**STAFF REPORT**  
**WEST ALLIS PLAN COMMISSION**  
**Wednesday, May 29, 2019**  
**6:00 PM**

- 2A. Special Use Permit for Holiday Inn Express, a proposed hotel, to be located at 10201 W Lincoln Ave.**
- 2B. Site, Landscaping and Architectural Plans for Holiday Inn Express, a proposed hotel, to be located at 10201 W Lincoln Ave, submitted by John T. Ford on behalf of the Lincoln Hospitality Group, LLC. (Tax Key No. 485-9996-007)**

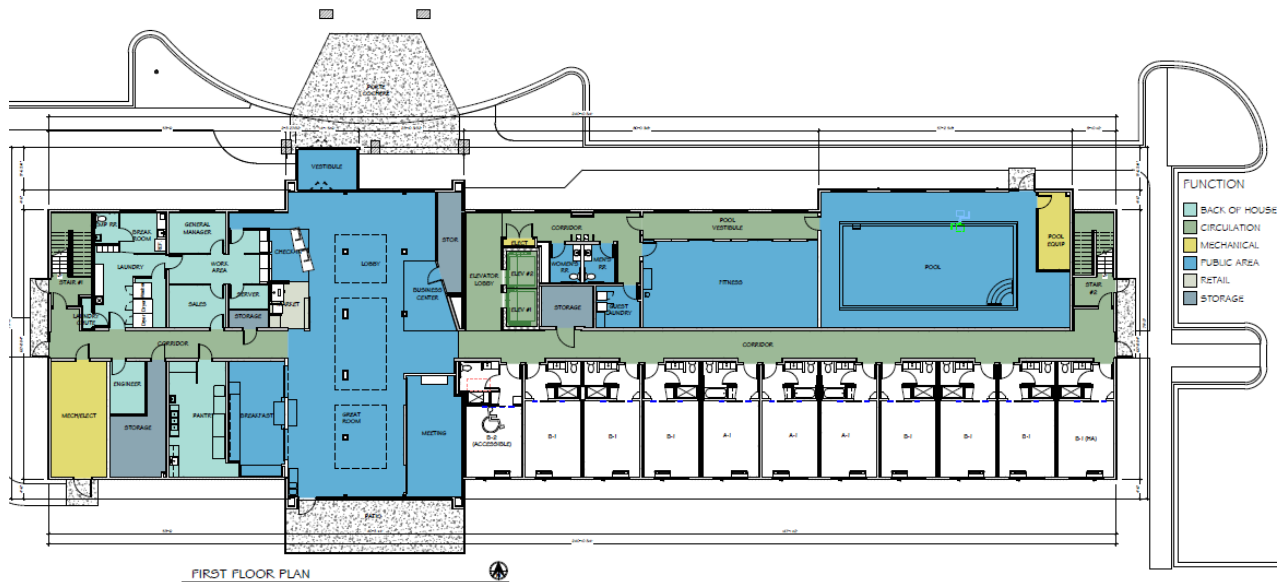
Building materials will be comprised primarily of manufactured stone veneer (southwest blend) around the base and a full proportion frame above the main entrance, aluminum composite panel (terra cotta), composite horizontal siding (light brown and cream), and composite panel siding (cream and sand). The entrance portico is comprised of a metal roof (granite) with columns made of steel framing and manufactured stone veneer to match the building. The building and portico will have metal coping, fascia, and soffit (bronze).

Windows and doors at entrances will be constructed of aluminum storefront systems (light bronze). Guest room windows will be constructed of aluminum (light bronze) and will be equipped with PTAC (packaged terminal air conditioners) located below the windows (champagne). Staff recommends that the storefront windows located at the building's entrance be replicated and continued throughout the first floor, in order to provide a more pedestrian-friendly approach and to add a greater sense of interest, openness and transparency to the design of the ground floor. Additionally, staff

**Staff Recommended: Additional windows on east & west elevations**

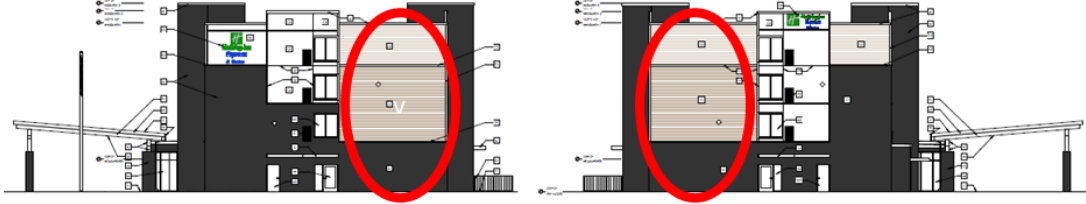
recommends additional windows be included on the east and west building elevations, in order to avoid large areas of opaque façade and to remain consistent with the requirements made of similar development projects.

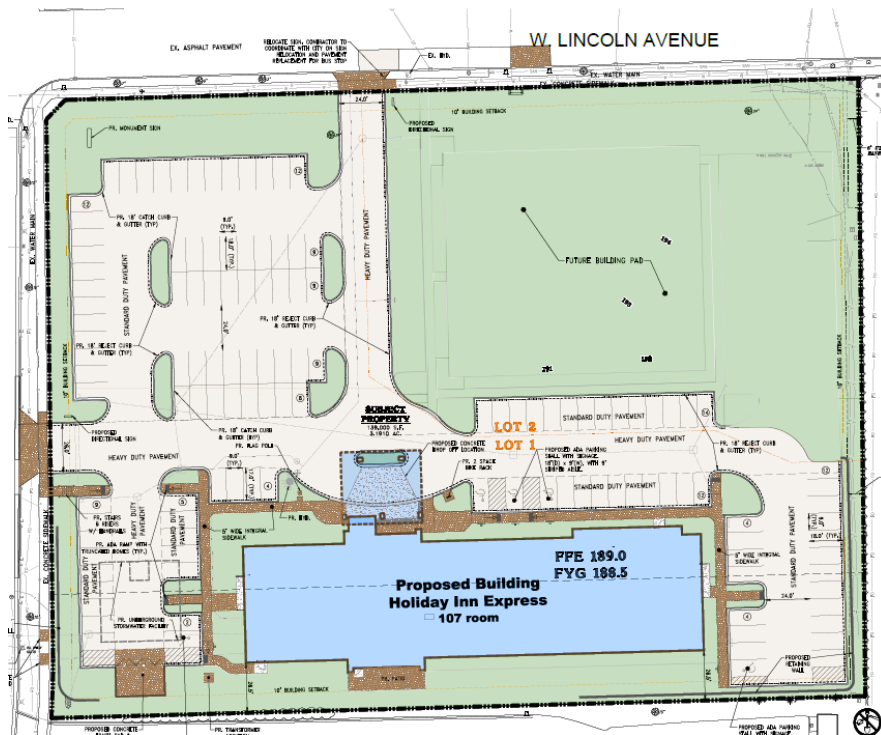
Vehicle access for the hotel will be available from the site's existing 102<sup>nd</sup> St. drive, as well as from a newly constructed Lincoln Ave. drive, which will be for vehicles turning right-in or turning right-out only. Pedestrian access to/from 102<sup>nd</sup> St. is included in the initial phase of development, with additional pedestrian access to Lincoln Ave. included as part of the future development project. Staff recommends that a pedestrian crossing area between the hotel entrance and the sidewalk connecting to Lincoln Ave. be shown on the site plan.

Hotel parking requirements call for one stall per lodging room, or 107 stalls. For the initial phase of development, the parking configuration of the hotel parcel (Lot 1) includes 111 stalls, consisting of the required 5 ADA stalls and 106 standard stalls. Additionally, 14 standard parking stalls will be included on the second parcel (Lot 2), with shared parking/cross access being established between the two parcels. Endcap landscape islands within the parking lot include a variety of deciduous trees and shrubs, and perennials.

- identified as Phase 1, Phase 2, and Contingency Plan; (b) City Forester approval of the landscaping species and number; (c) additional pedestrian connection/crossing from hotel entrance toward Lincoln Avenue; (d) sidewalk/pedestrian connection to Lincoln Ave. clearly identified on the Contingency Plan; (e) Implement by date included on Contingency Plan; (f) revised window plan for the first floor, as approved by staff; (g) additional windows added to the east and west elevation, as approved by staff; (h) staff approval of material and color samples; and (i) City Engineer approval of new entrance/drive location and design. Contact Katie Bennett, City Planner at 414-302-8463.

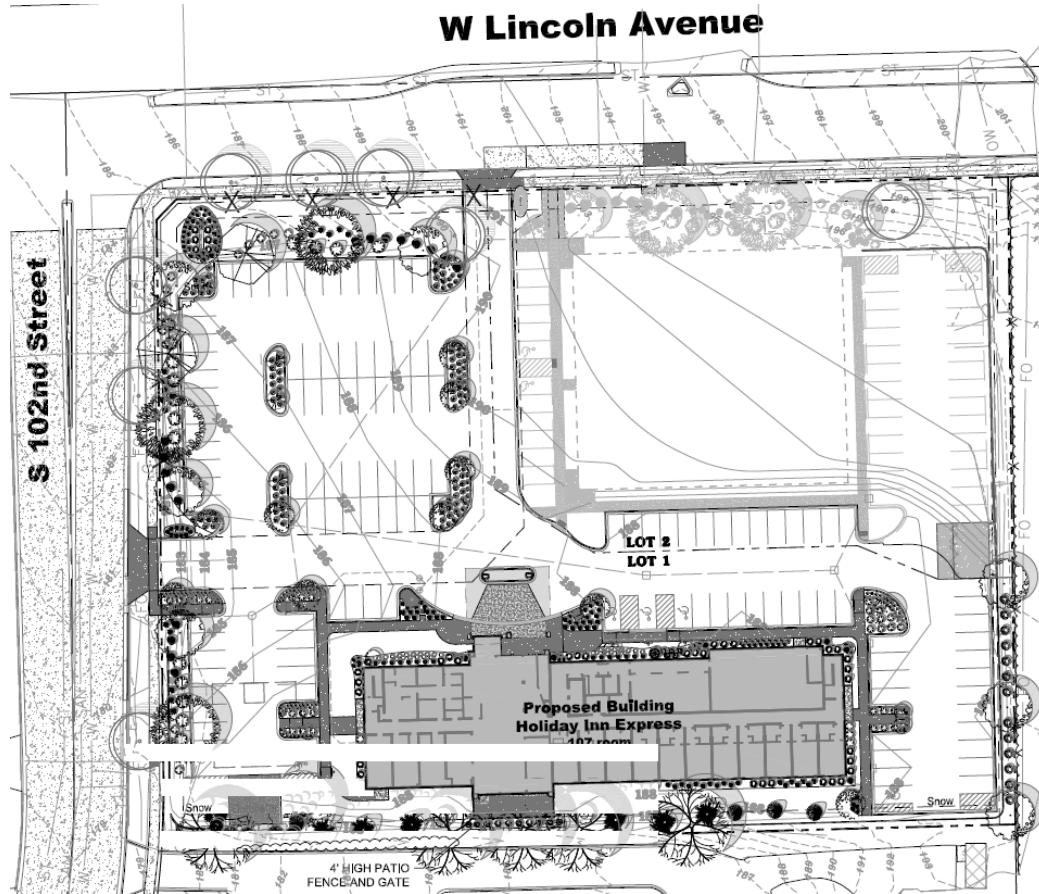
For the initial development project, a wide selection of deciduous trees and shrubs, evergreen trees and shrubs, and perennials are proposed on Lot 1. As part of the contingency plan, should no development be underway on Lot 2 by June 2021, additional landscaping is proposed along Lincoln Ave. Staff recommends that a sidewalk/pedestrian connection from the hotel to Lincoln Ave. also be clearly identified as part of the contingency plan.
